April 12, 2019

Version 2

Safety Recall: 3.5L V6 Timing Belt

Supersedes 19-026, dated April 12, 2019, to revise the information highlighted in **yellow**

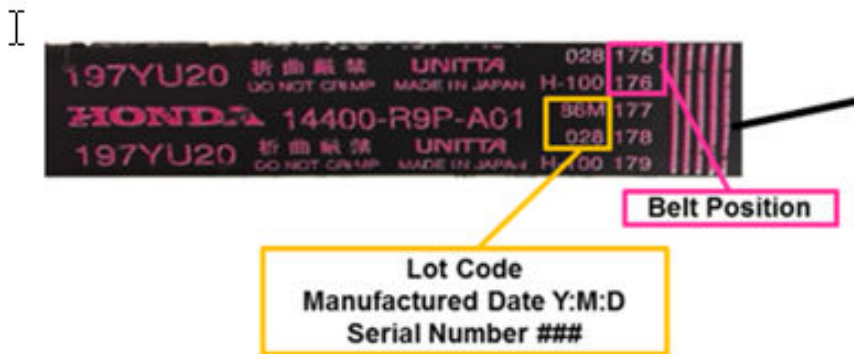
Under INSPECTION, Step 5 was changed.

5. Rotate the engine clockwise until you see the timing belt manufacturing information (lot code) or until the mark you made on the timing belt is visible again.

- If the lot code is visible, go to step 6.
- **If the lot code is not visible, go to TIMING BELT REPLACEMENT.**
